STATE OF CONNECTICUT  
CONNECTICUT SITING COUNCIL

IN RE:	:	
	:	
A PETITION FOR A DECLARATORY	:	PETITION NO. 1425
RULING THAT A CERTIFICATE OF	:	
ENVIRONMENTAL COMPATIBILITY AND	:	
PUBLIC NEED IS NOT REQUIRED FOR THE	:	
CONSTRUCTION, OPERATION AND	:	
MAINTENANCE OF A 1.9 MWAC SOLAR	:	
PHOTOVOLTAIC PROJECT AT 360	:	
GAYLORD MOUNTAIN ROAD IN HAMDEN,	:	
CONNECTICUT	:	DECEMBER 8, 2020

**LATE-FILED EXHIBITS RESPONSES OF  
GAYLORD MOUNTAIN SOLAR PROJECT 2019 LLC**

SHEET NUMBER:  
**EXH-1A**

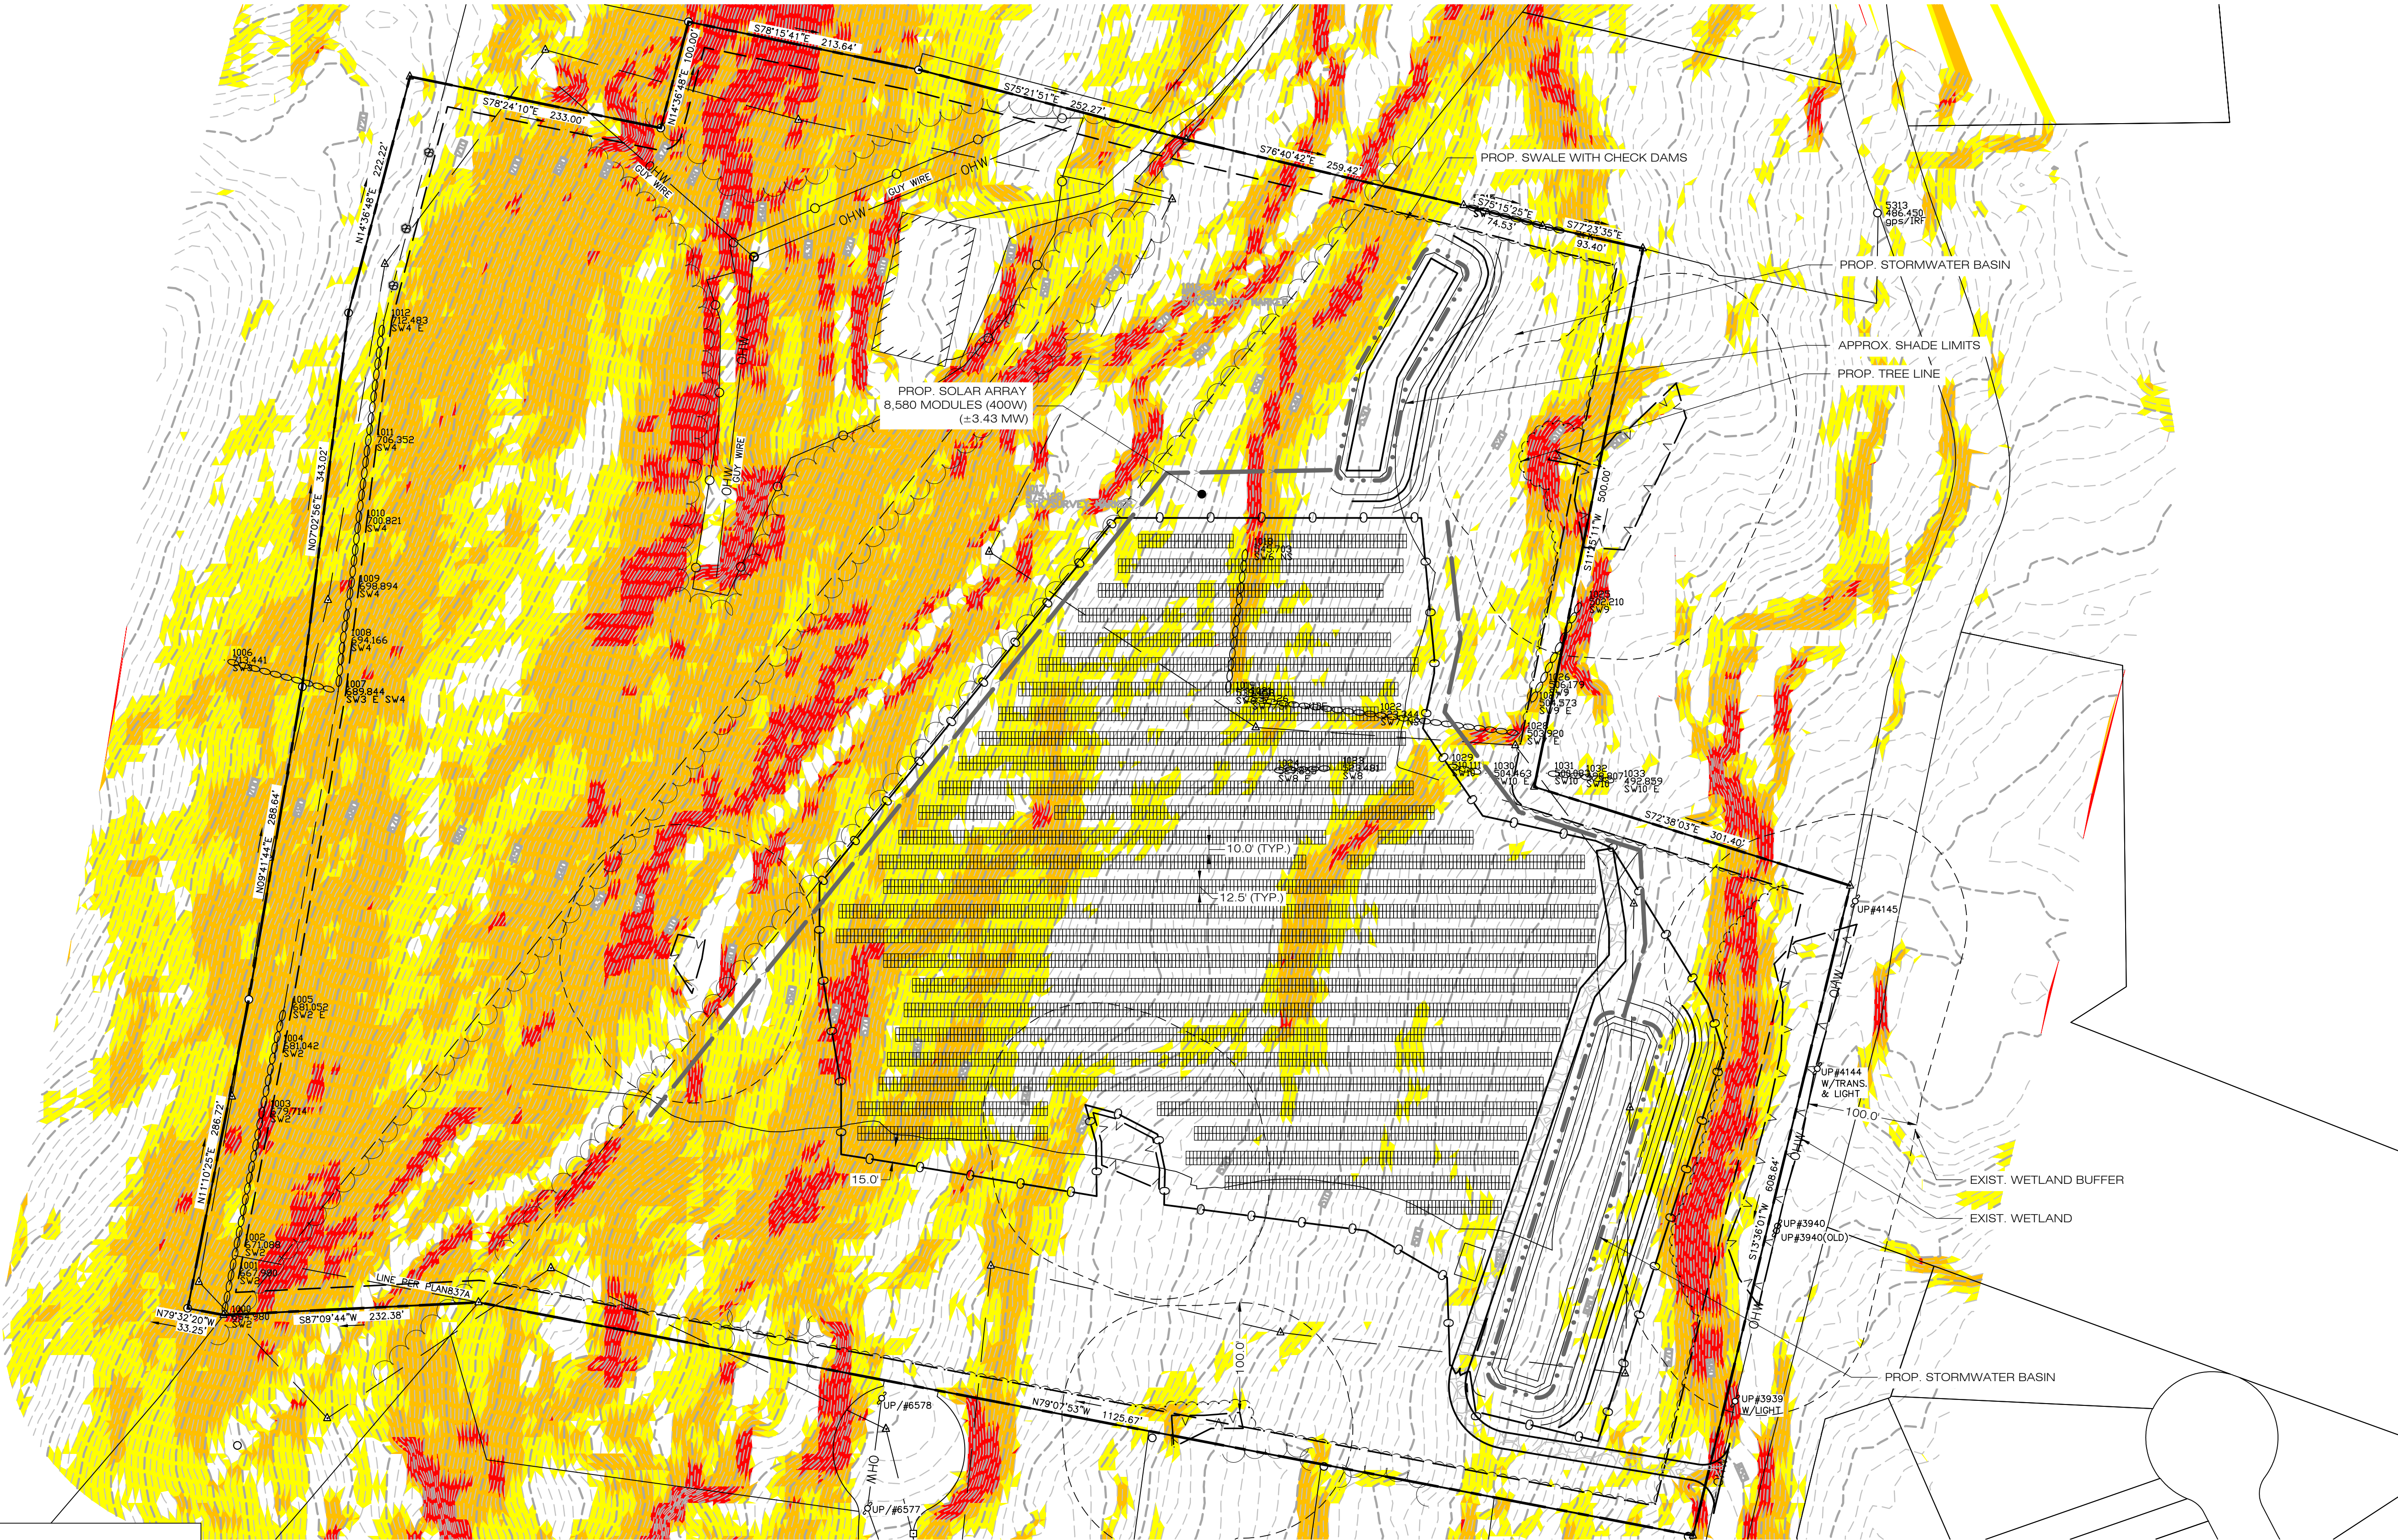
(b) Provide acres of solar field area located on slopes greater than 15 percent to include a site plan of such locations.

Included in Exhibit 2 is a topographic map of the Project Site including the layout of the solar arrays as proposed in Petition No. 1425. This map illustrates how the Petitioner has avoided, to a significant extent, the installation of solar arrays on the steepest portions of the parcel where possible. Exhibit 2 shows that within the limits of the 8.59 acre fenced-area, where the solar arrays would be located, only 1.71 acres (approximately 20%) maintain slopes greater than 15% grade. As illustrated on the Exhibit 2 map, the area where the solar panels are located on steeper grades (greater than 15%) is only 0.34 acres, approximately 4% of the 8.59-acre fenced area.

CP-2

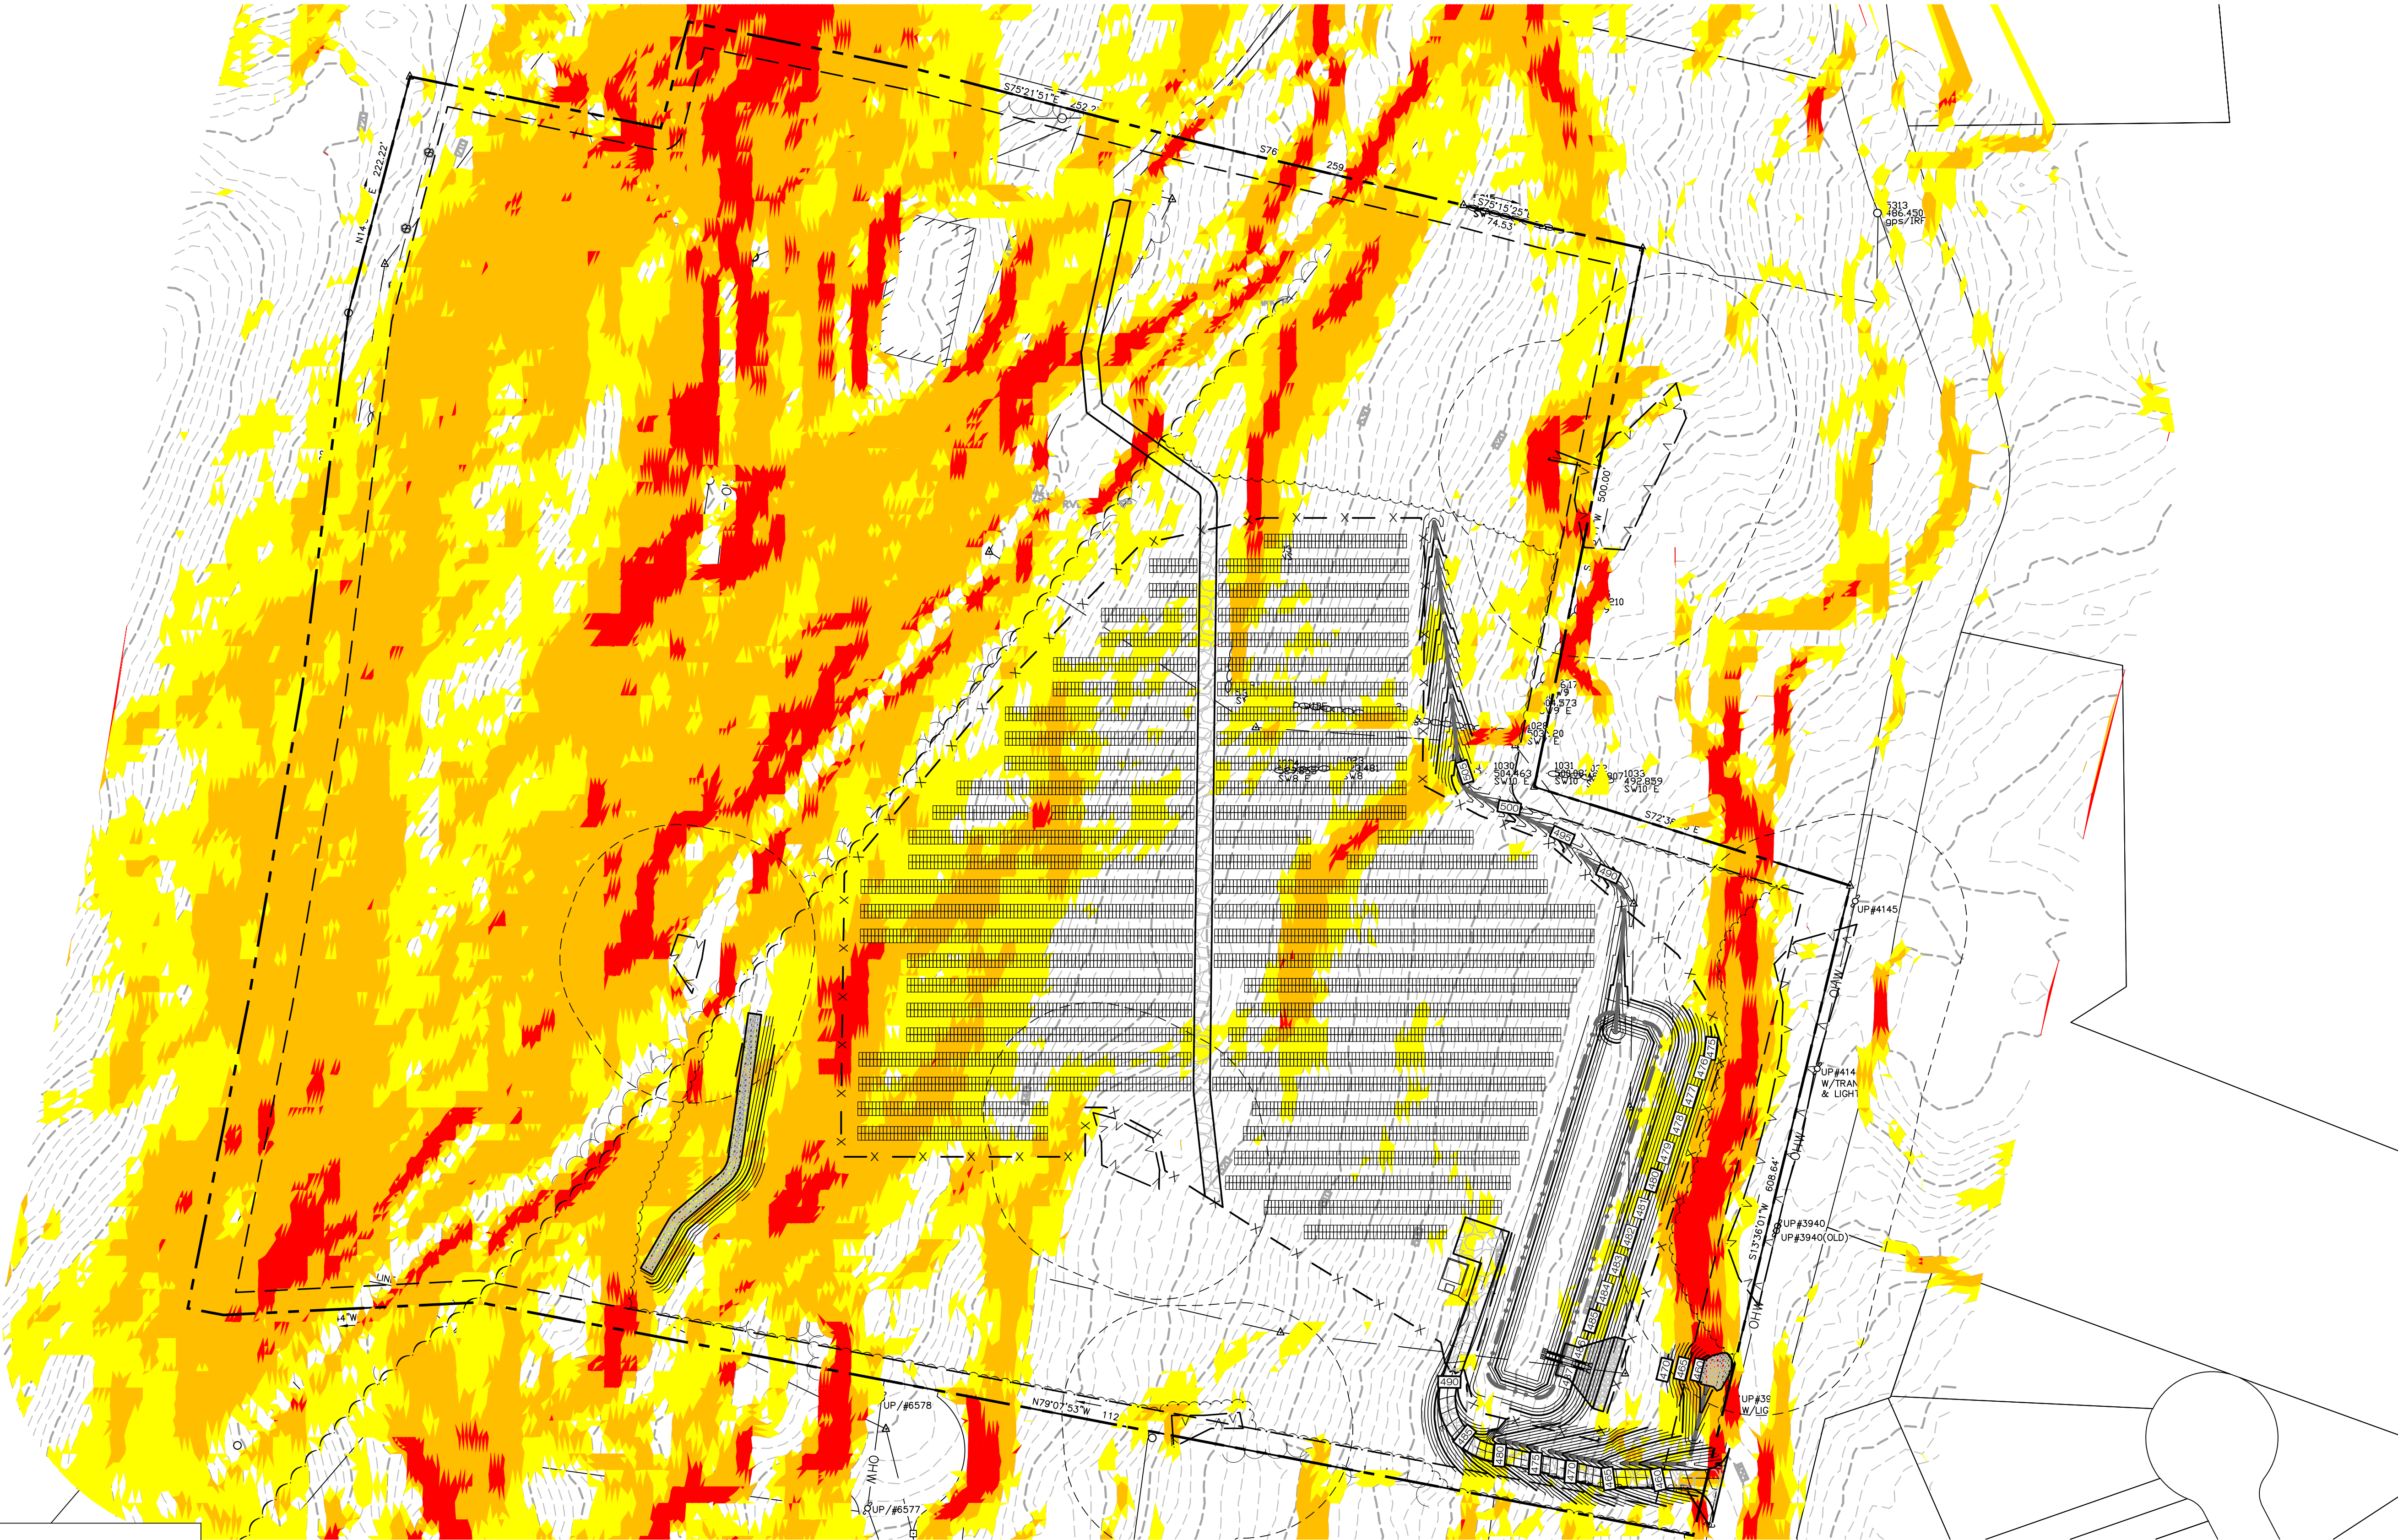
Between March and the end of April, the Petitioner continued to refine the Project design resulting in the layout shown in Exhibit 4, which was presented to DEEP at the May 10, 2020 meeting referenced in the Petition on page no. 9. As you can see, the layout shown in Exhibit 4

still had the solar panels orientated to face due south and included solar panel coverage on some of the site's steeper slopes (up to 30%). The layout shown in Exhibit 4, however, includes the addition of a construction access road from the north and a further reduction in the number of solar modules to 6,968, still 676 more modules than currently proposed. This layout also results in a loss of 0.645 MW and 15% of energy production over the layout presented in Exhibit 3.

As described in more detail in response to Council Interrogatory No. 56, the Petitioner met with DEEP on multiple occasions to review the Project layout and made further Project adjustments based on DEEP's recommendations. The current Project layout included in the Petition and as shown in Exhibit 2 illustrates the Petitioners willingness to make important compromises to reduce the Project's overall environmental effect, particularly those related to stormwater and soil erosion and sediment control which would minimize any potential impact the Project may have on water quality. Information regarding the effect these compromises have had on the energy output from the solar facility is included in the Petitioner's response to LFE (i) below.
